POLICY REPORT
DEVELOPMENT AND BUILDING

TO: Vancouver City Council
FROM: General Manager of Planning and Development Services
SUBJECT: CD-1 Rezoning: 6729 - 6769 Cambie Street

Site Plan/Landscape Plan

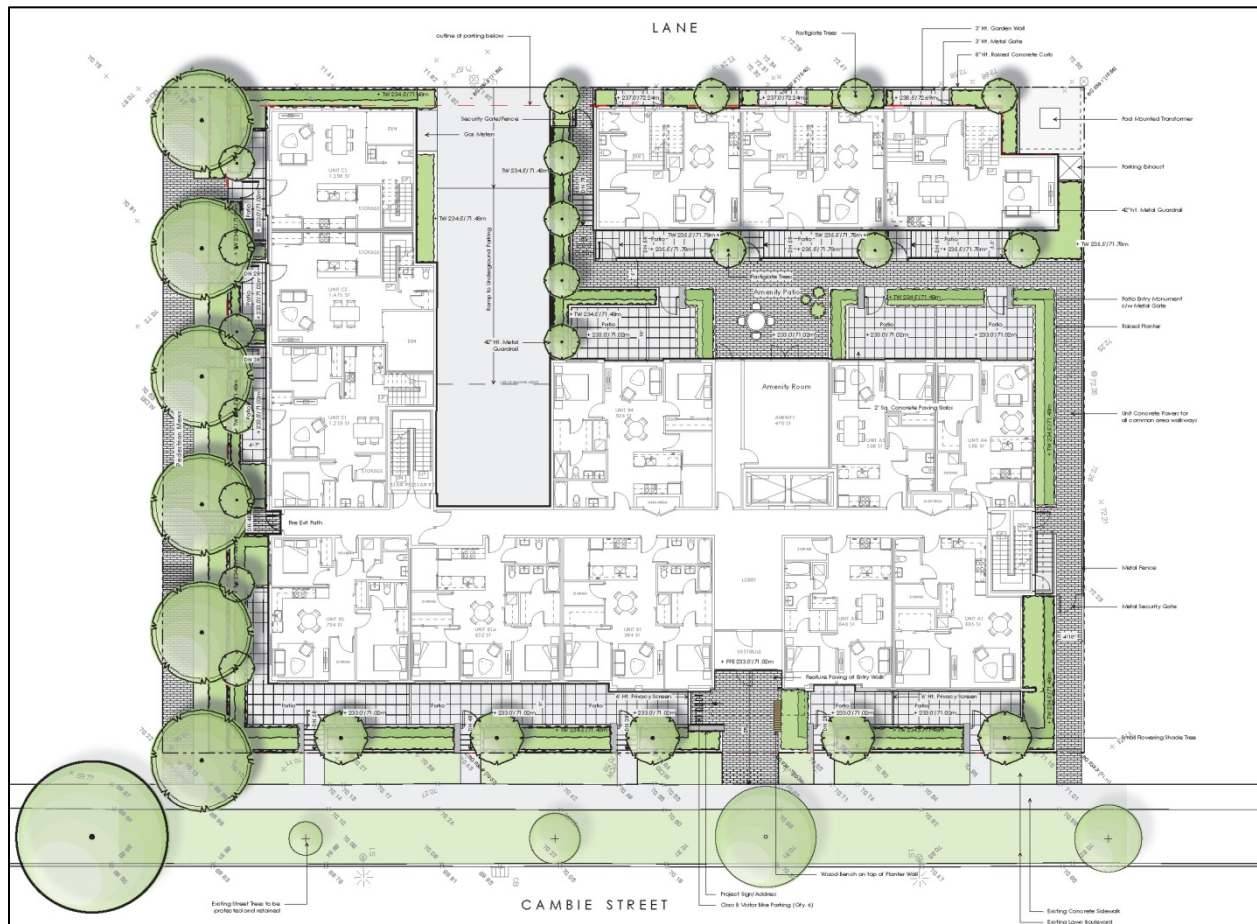
Related Commentary: Although the proposed height, massing and colour-scheme are all supportable this project lacks any real character and does not contribute to the Cambie streetscape. It embodies much of the current developments which already exist, and the applicants are encouraged to mix things up a bit more in their design.

There appears to be a lack of outdoor space which could be solved by increasing the 'front yard' sizes off Cambie Street and adding trees and increasing the size of the patios to allow for furnishing. Making the top patio space public instead of private would also help with this. The courtyard doesn't contribute much to the outside space and needs to be more interesting.

The mid-block connection currently just exists and needs to have a much bolder entryway. The mews doesn't appear to be anything other than a six-foot walkway, and doesn't contribute to the urban fabric. If the vertical brick had a lot more depth and the ends contrasted more with the centre, it would do a lot to announce the front entrance and to better the public/private realm interface.

The amenity space is currently too small and awkwardly located. Look at relocating it in a way which activates the mid-block connector. Applicants should also consider having the building address sustainability with passive design strategies. Overall the building does nothing to warrant the increased density that it seeks, and needs to express more character and vision as well as provide more laneway activation and neighbourly friendliness.
